## **INFORMATION LETTER 407-06-91**

**SUBJECT: AIRCOMM CORP S.T.C. #SR00222DE AIR CONDITIONING KIT**

**Service Bulletin:** SB407-3526; Bell 407 Air Conditioner Drive Pulley Bevel Washer Replacement.

**Subject:** Tail Rotor Driveshaft Bevel Washer Replacement.

Installation Configuration -2 (Installation of S-3526EC-7 Bevel Washers)

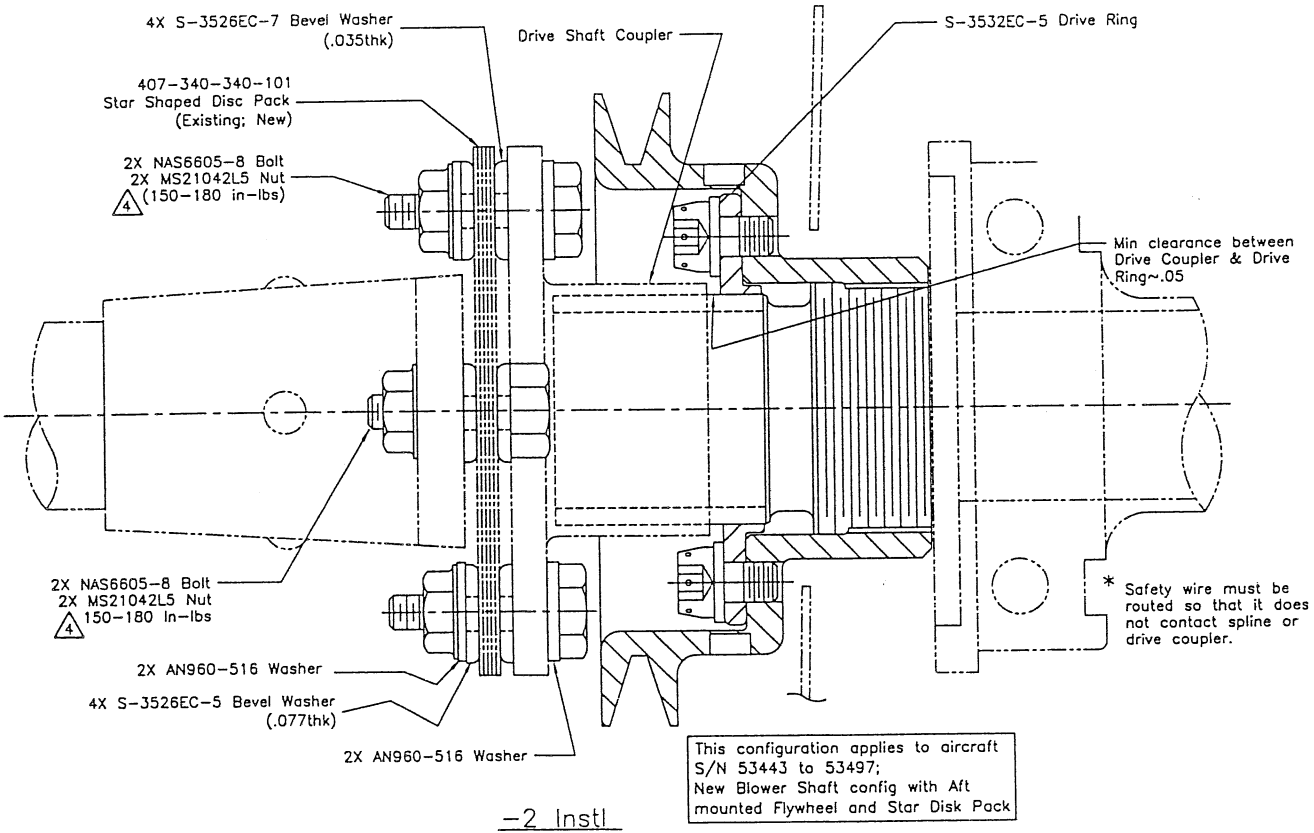
Field inspections have indicated that some wear maybe occurring between the inside shoulder of the S-3526EC-4 Bevel Washer and the base of the NAS6605 Bolt head on Bell 407 Helicopters equipped with an Air Comm air conditioner system.

Rev A: S-3526EC-7 replaces the S-3526EC-4 or -6  
Date: Jan 14, 2007

The purpose of this bulletin is to remove, and replace the affected existing attaching hardware from the disc pack coupling just forward of the air conditioner drive pulley.

Configuration	Part Number	Description	Quantity
<b>-2</b>	S-3526EC-7	Bevel Washer	4
	NAS6605-8	Bolt	2
	MS21042L5	Nut	4
*	*	*	*
<b>-3</b>	S-3526EC-7	Bevel Washer	4
	NAS6605-10	Bolt	2
	MS21042L5	Nut	4

4. Torque all fasteners in accordance with the specific Applied torques shown on the face of the illustrations for the appropriate configuration ( -2, or -3).

**The recommended standard torque range is given in the following drawings.  
\*Tare "Drag" Torque shall be added to the torque value listed unless otherwise stated.**
